**Technical Service BULLETIN**

Title: **EXCESSIVE SULFUR DIOXIDE ODOR**

Models: '03 – '04 Corolla

ENGINE  
EG016-04

**ECM (PCM)  
Identification  
Chart**

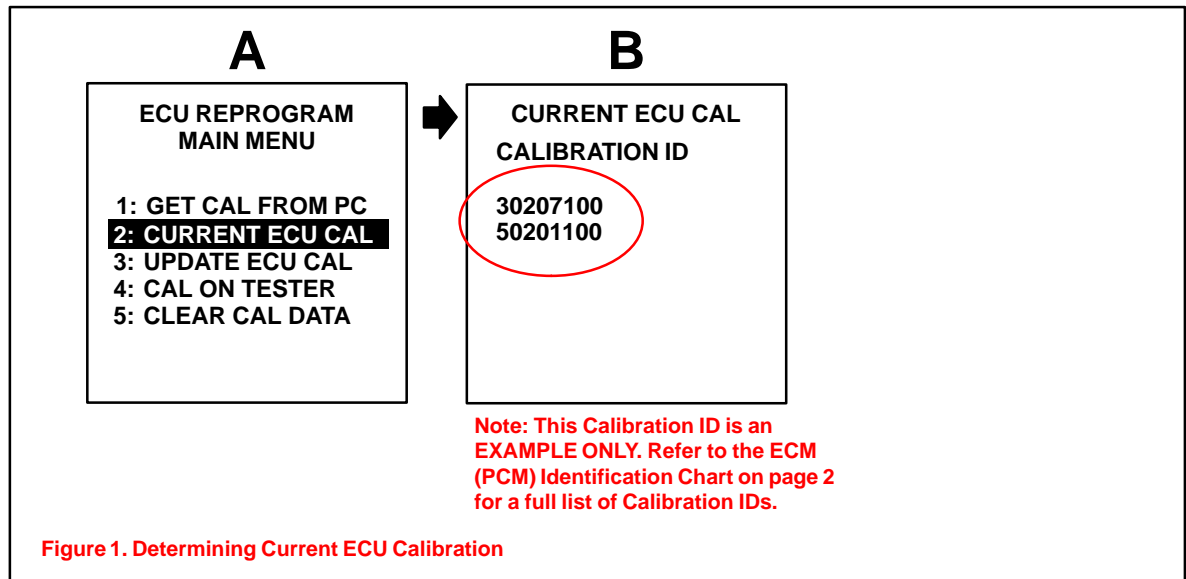
MODEL YEAR	DRIVETRAIN	ECM SUPPLIER	ECM (PCM)	PREVIOUS CALIBRATION ID NUMBERS	NEW CALIBRATION ID NUMBER
2003	MTM	Denso	Main	30201000	30201400
				30201100	
	ATM	Denso	Main	30201200	
				30201300	
ATM	Delco	Main	30202000	30202300	
		Sub	30202100		
				30202200	
2004	MTM	Denso	Main	50201100	50201400
				50201200	
	ATM	Delco	Main	50201300	
			Sub	30216000	
				30217000	30217200
				30217100	
				30214000	30214100
				50203000	50203200
				50203100
